Review Comments
Electrical Recommended Change Order #42
First fifteen plan sheets
{85R1,91R1,93R1,117R1,118R1,119R1,120R1,121R1,122R1,132R1, 133R1,141R1,142R1,154R1,172R1}
Michael Travis

MARK	DATE	DESCRIPTIONS	BY	CHK	CCO
A	8-06-07	Revision to misc. electric works. Clarity Interface between cable tray and conduit.	MP	EL	SO
		REVISIONS			42

DIST	COUNTY	ROUTE	KILOMETER POST TOTAL PROJECT	SHEET NO	TOTAL SHEETS
04	SF	80	13.2/13.9	85R1	1204

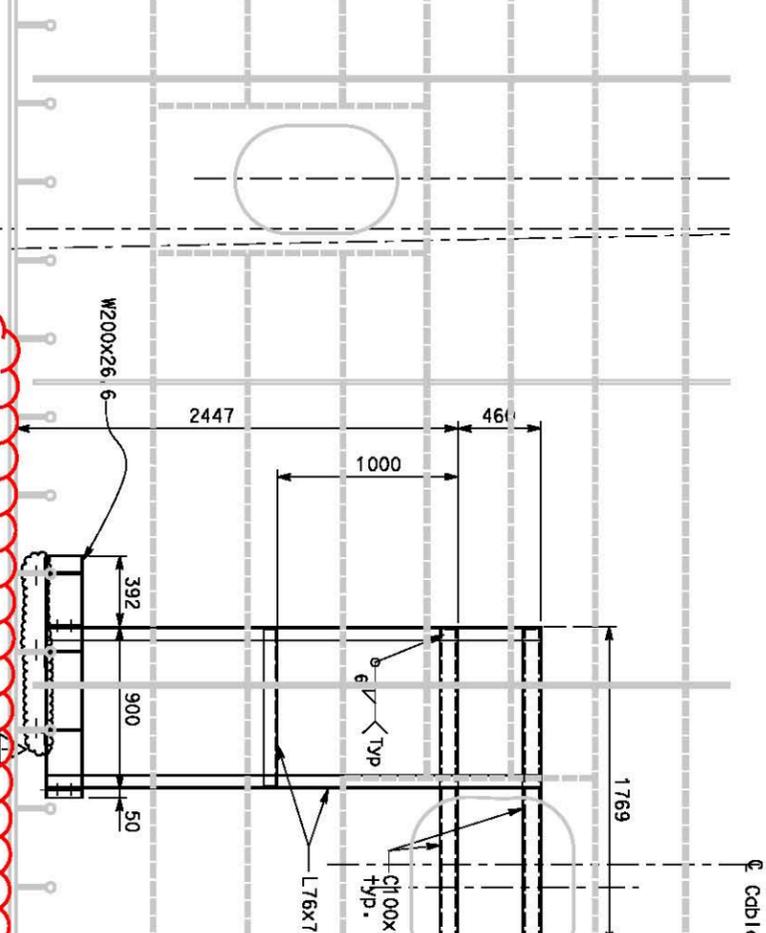
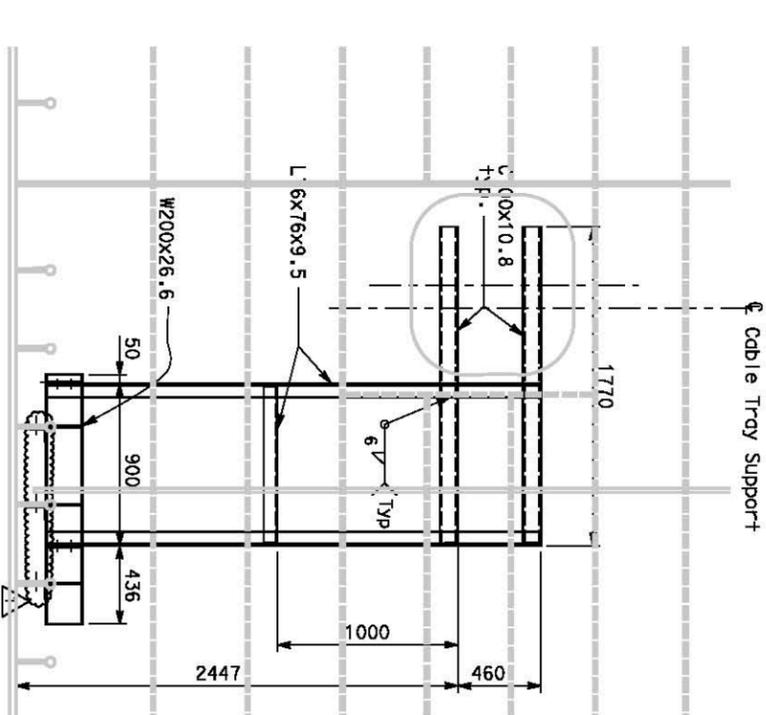
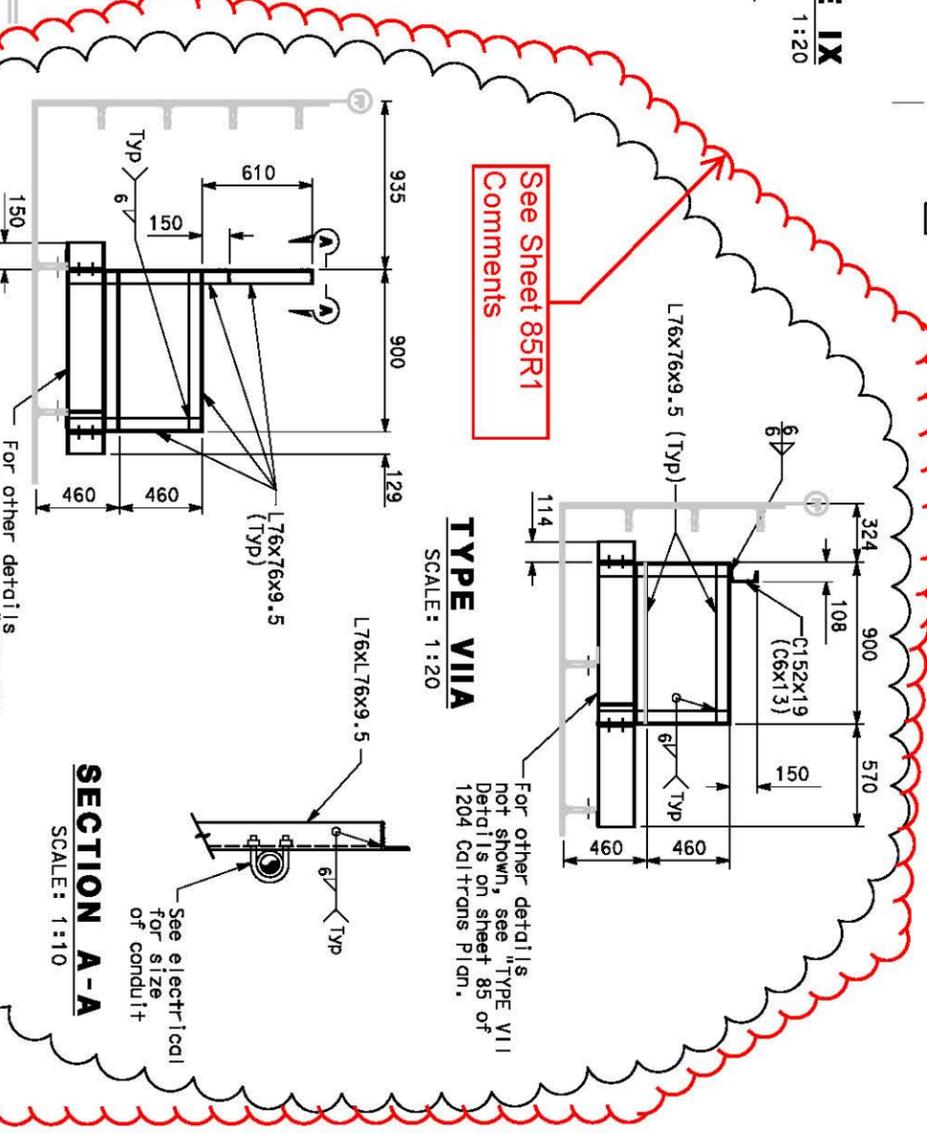
NOTE: By placing added details on the sheet reduces area to add any additional information on this sheet in the future if additional changes are required. If new details are added one should consider producing a supplemental sheet for new details.

- ❖ **Added details were placed in this CCO but no sheets in this CCO reference these new details. Need to add the appropriate sheets or remove these details from the CCO.**

DIST	COUNTY	ROUTE	KILOMETER POST TOTAL	SHEET NO	TOTAL SHEETS
04	SF	80	13.2/13.9	93R1	1204

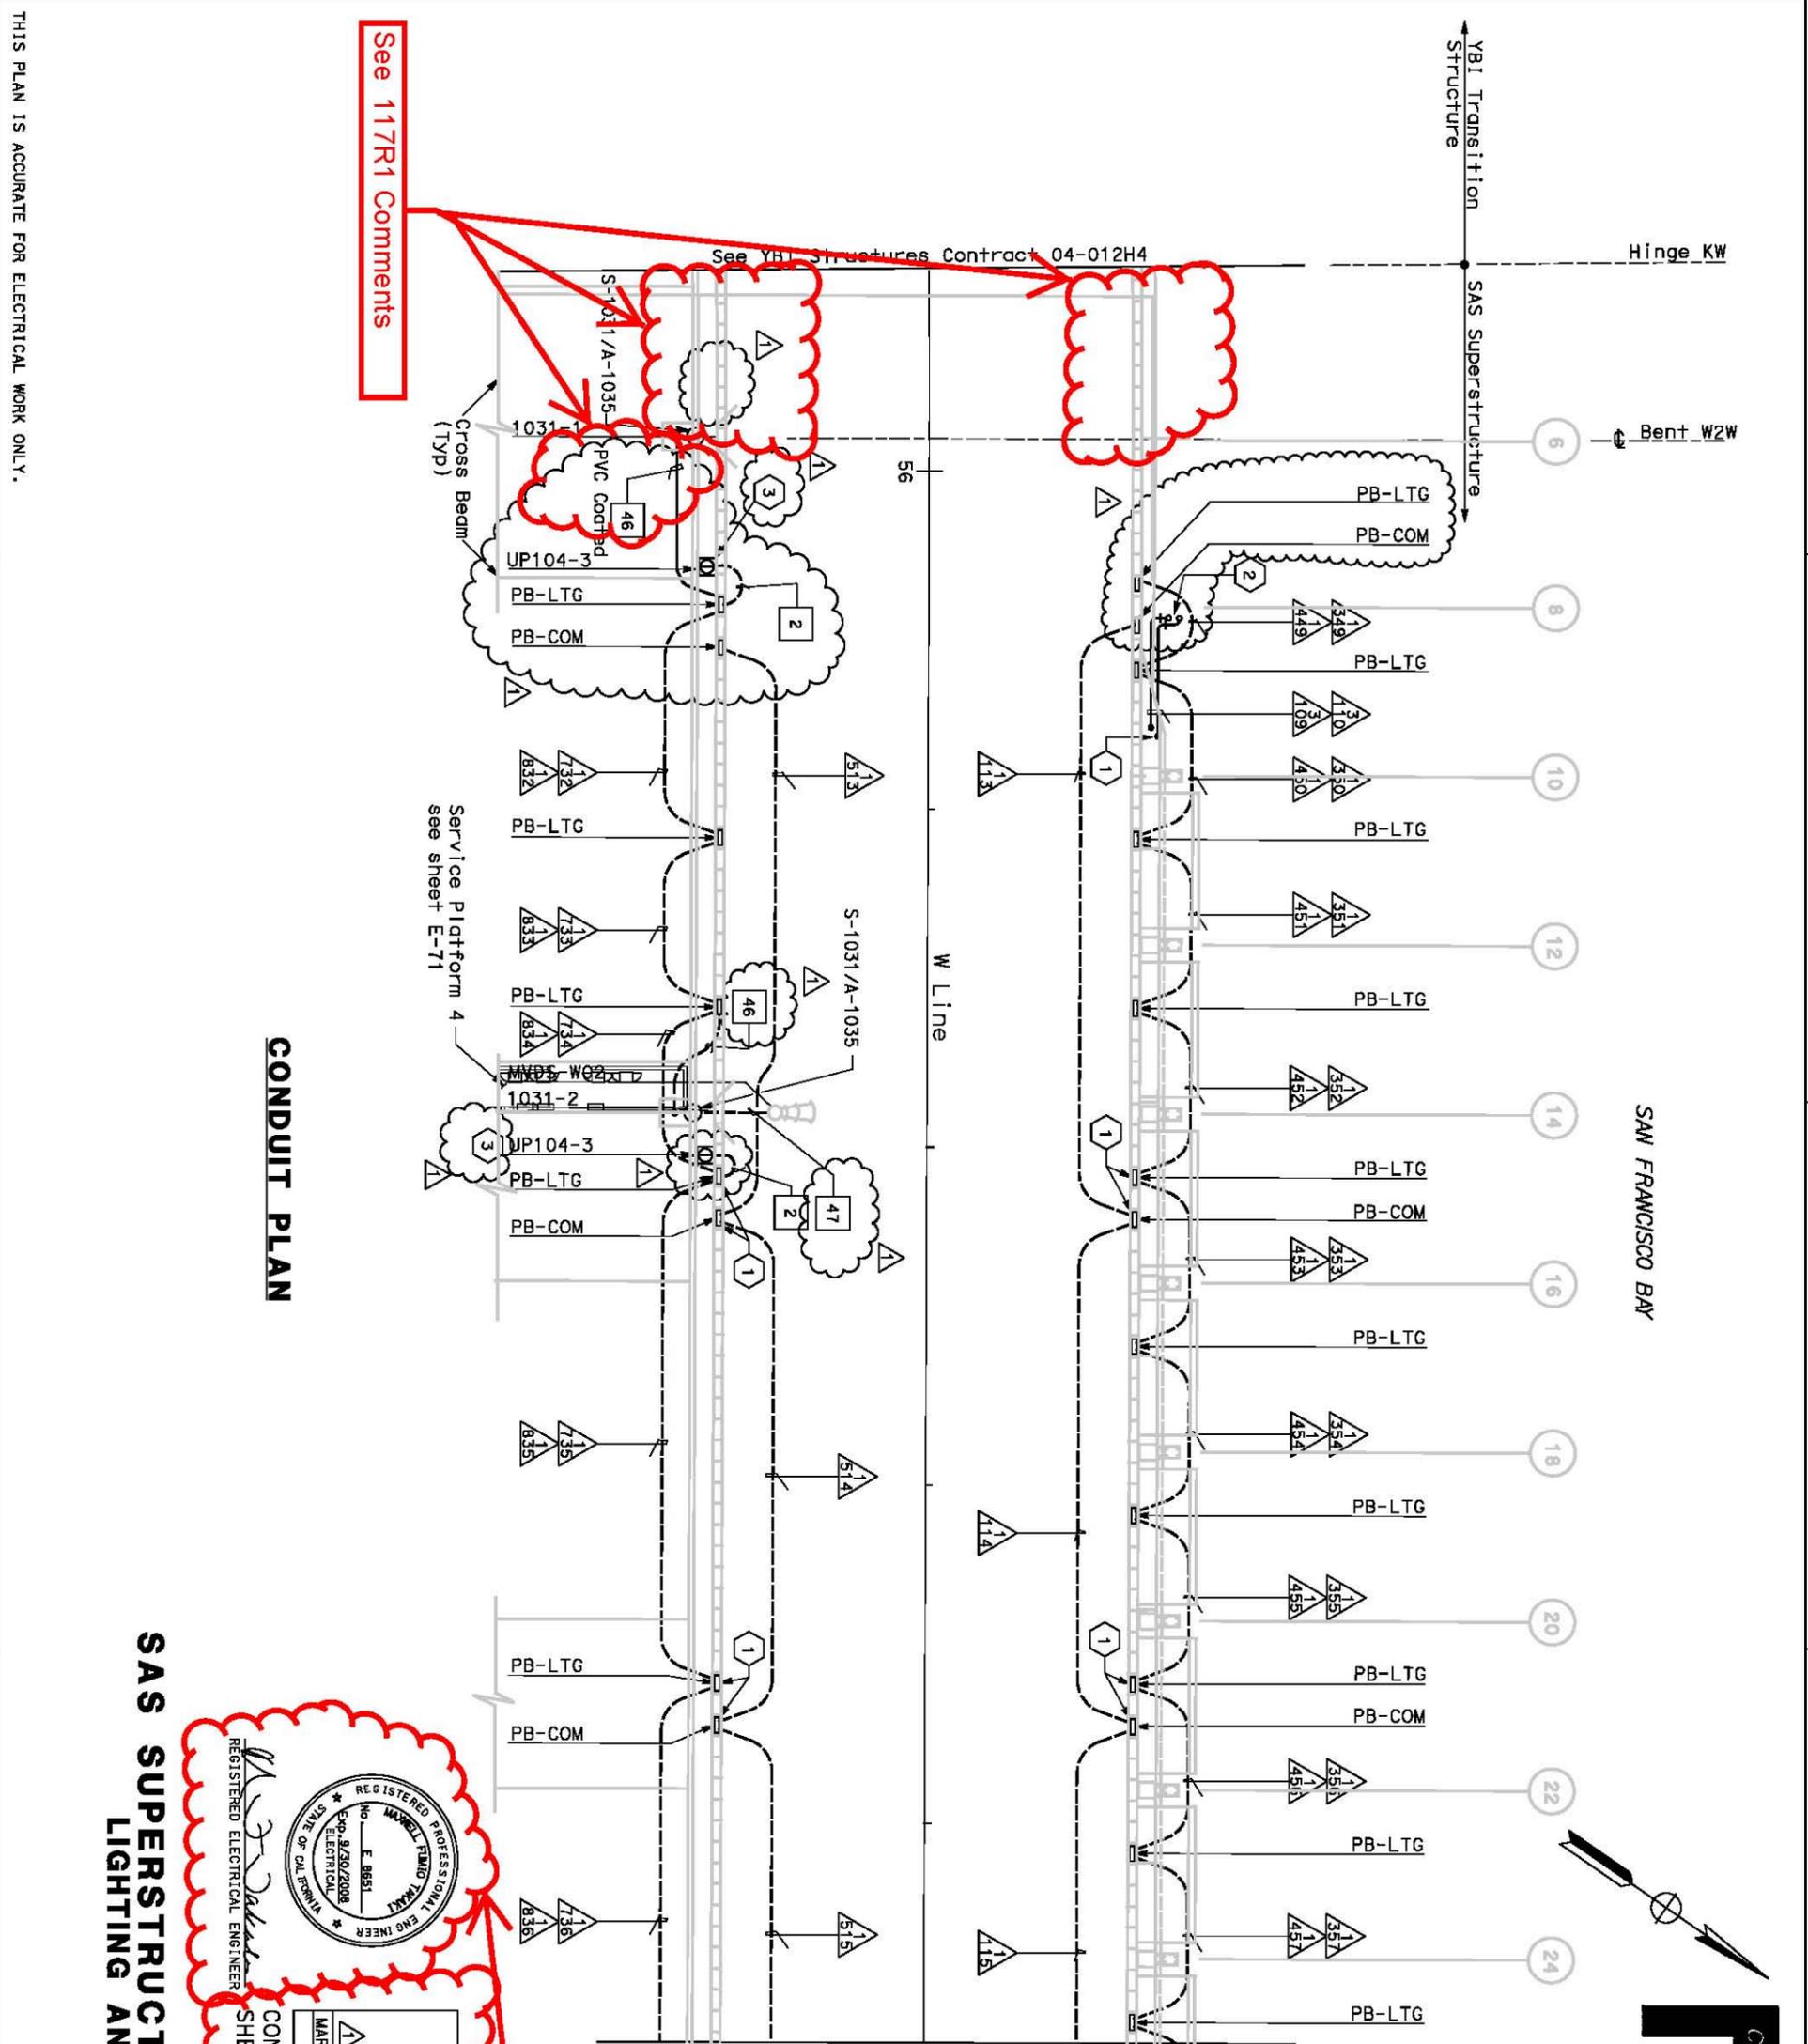
- ❖ **After working with the pole pedestal prototype that was develop to evaluate the routing of the conduit feeds to the light poles Caltrans is requesting to reconsider the response to RFI # 261 with the following exceptions: (1) Provide holes in the pedestal top plate to accommodate 3- 41mm conduit penetrations; (2) Provide three sleeves in the top deck plate in the pole pedestal enclosure; (3) Use flexible metallic conduit to feed from the OBG to the pole mounting area.**

DIST	COUNTY	ROUTE	KILOMETER TOTAL PROJECT	POST MILE	SHEET NO.	TOTAL SHEETS
04	SF	80	13.2/13.9	117R1	1204

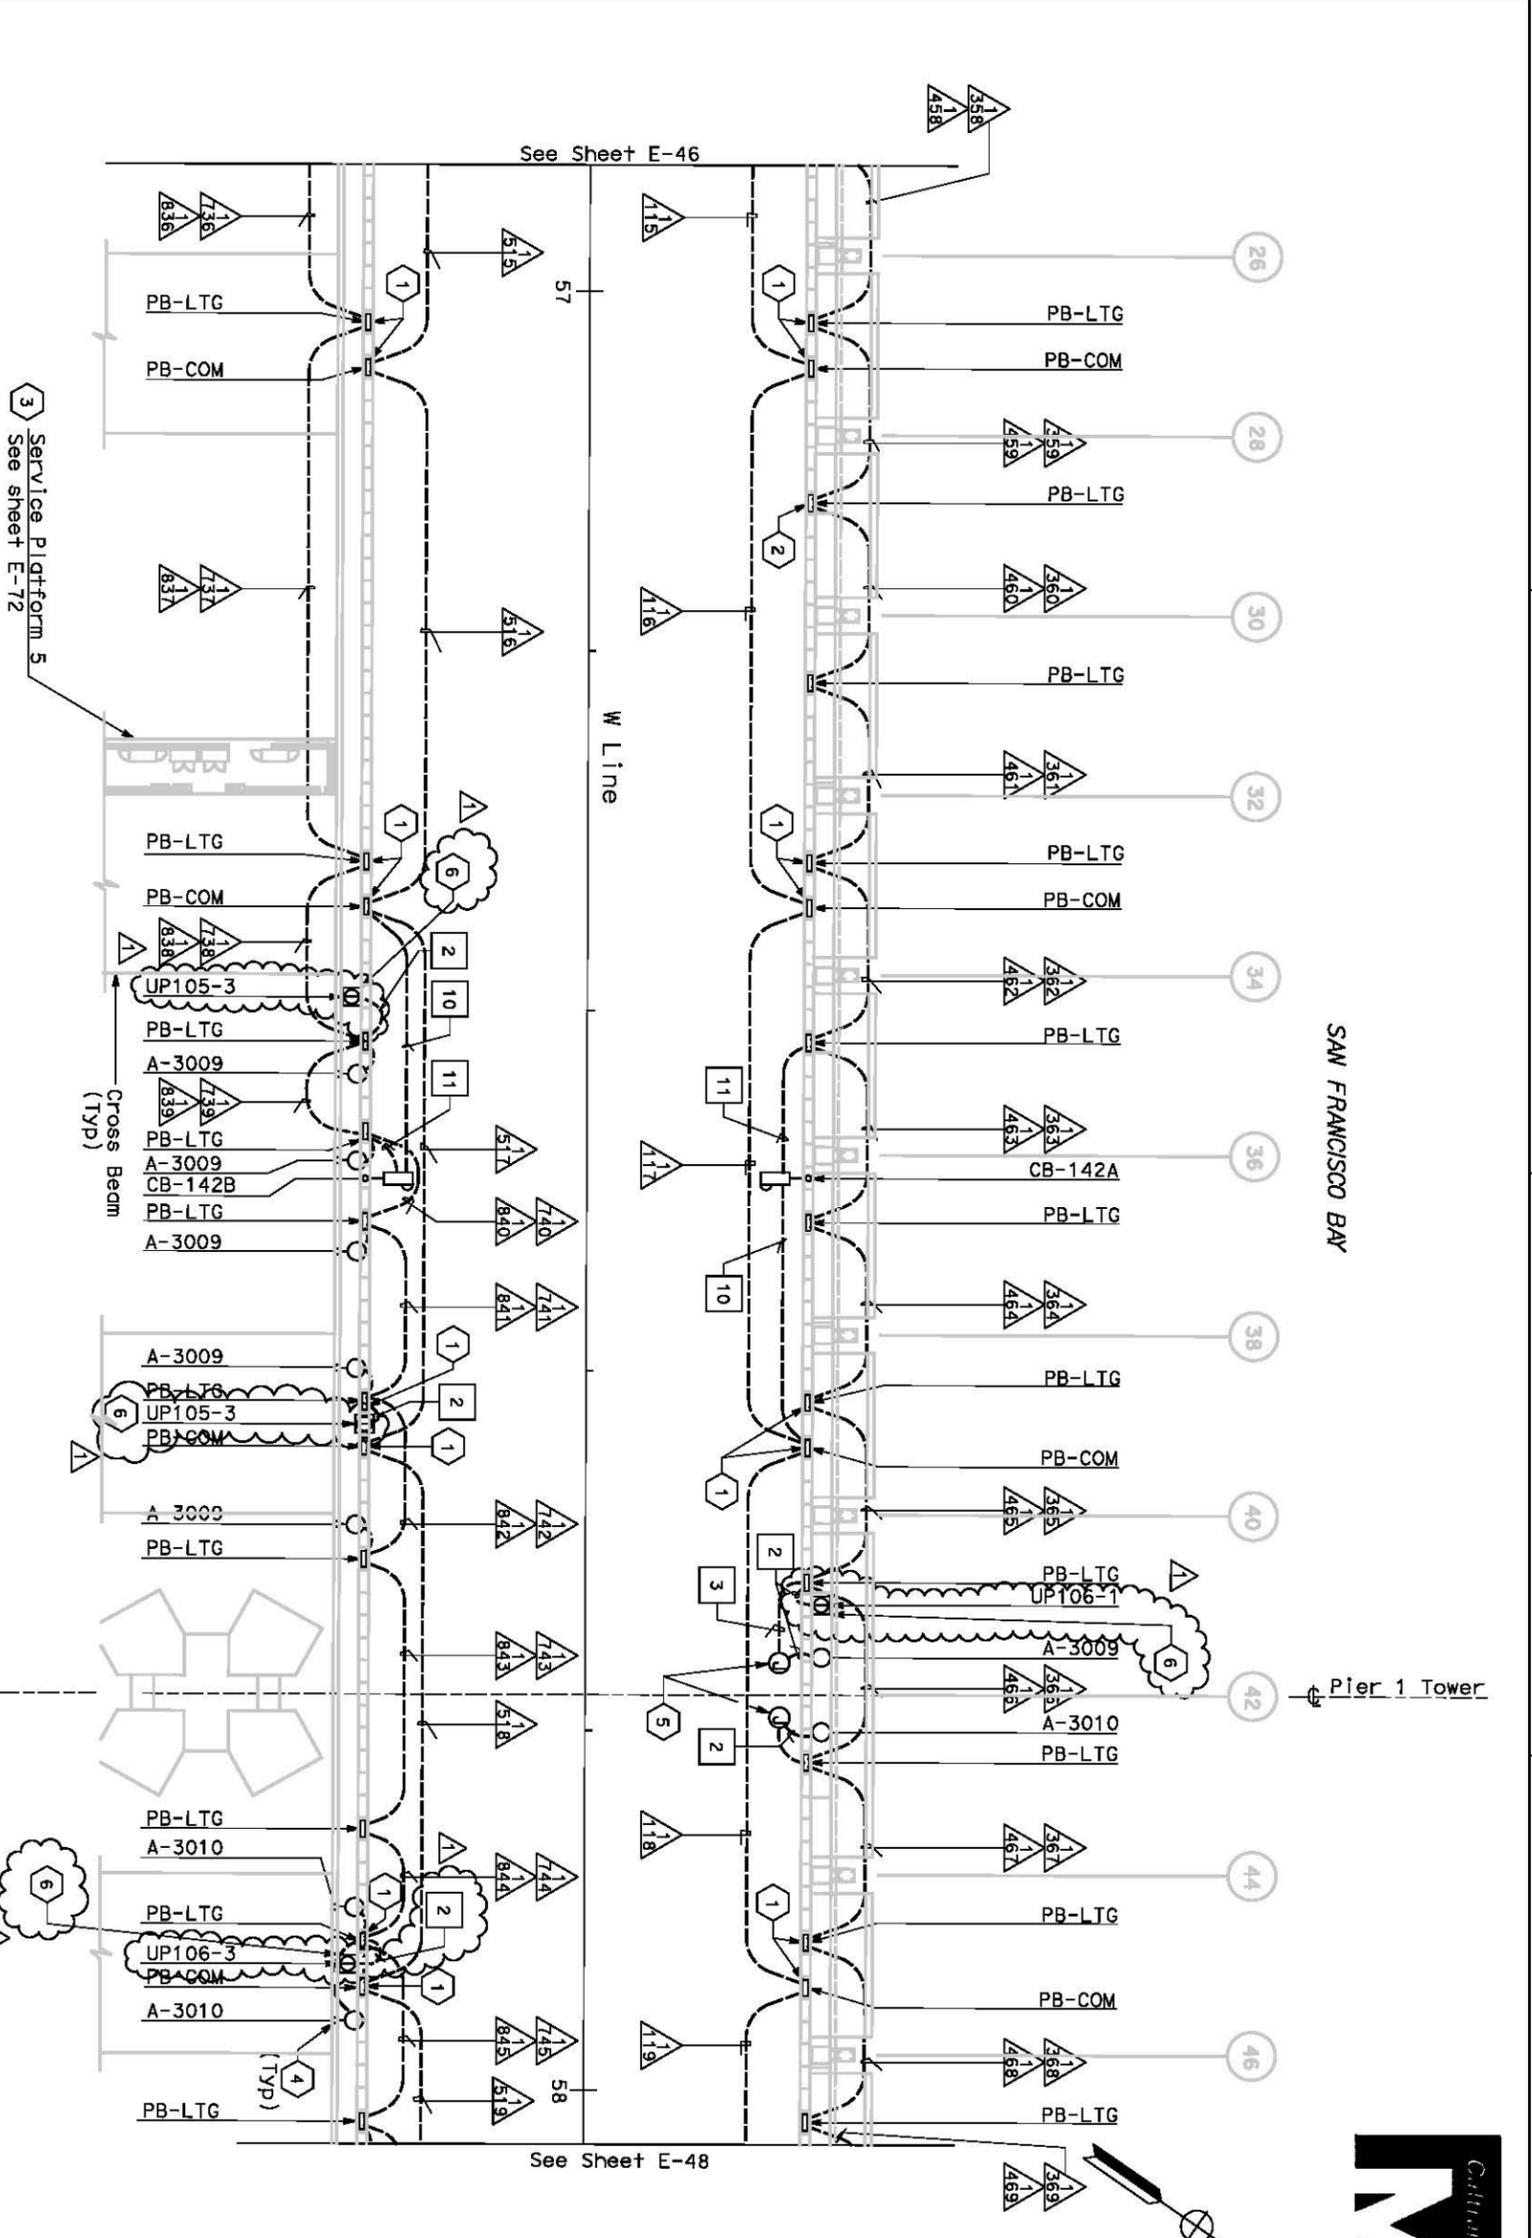
- ❖ There is a missing clouded area which has deleted junction box, conduit. The other area is clouded. Need to be consistent.
- ❖ After working with the pole pedestal prototype that was develop to evaluate the routing of the conduit feeds to the light poles Caltrans is requesting to reconsider the response to RFI # 261 with the following exceptions: (1) Provide holes in the pedestal top plate to accommodate 3- 41mm conduit penetrations; (2) Provide three sleeves in the top deck plate in the pole pedestal enclosure; (3) Use flexible metallic conduit to feed from the OBG to the pole mounting area.
